Re: Rapiscan AIT System Radiation Survey Reporting

**R-0646-1 Addendum
(Documentation Errors)**

Product Name	Secure 1000SP (Single Pose)
Serial Number	S51005002
Radiation Emission Measurement	Radiation Survey Dated: 05/25/2010
RSO Initials

1. In Beam Dose Measurement: Survey Table. 1

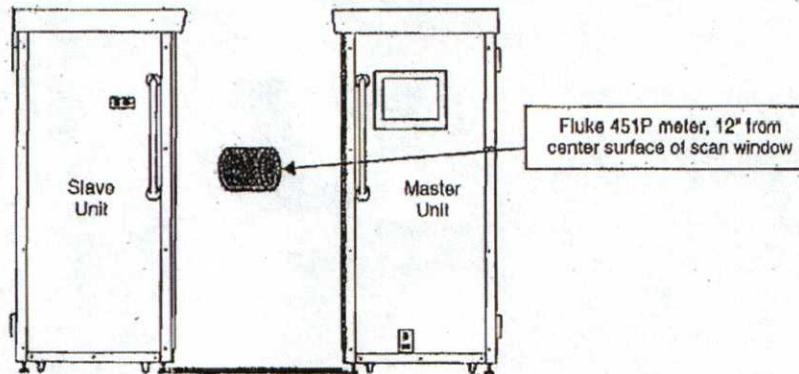
1. No value indicated for background radiation. Typical values range from 7uRem/hr to 13uRem/hr at sea level. Note: Absence of value has no adverse impact on calculations.
2. Technician indicated scan time as 7 seconds. Correct scan time is 3 seconds.
3. TABLE 1: Incorrect presentation of data in Column 3 for Measured Exposure. Indicated values are 29uR and 36uR. Corrected values are 2.9uR and 3.6uR. The values were corrected by technician when calculating Effective Dose.

The service technician should attend refresher training.

The corrected data indicates this system was operating within expected parameters. No re-survey is required for this system.
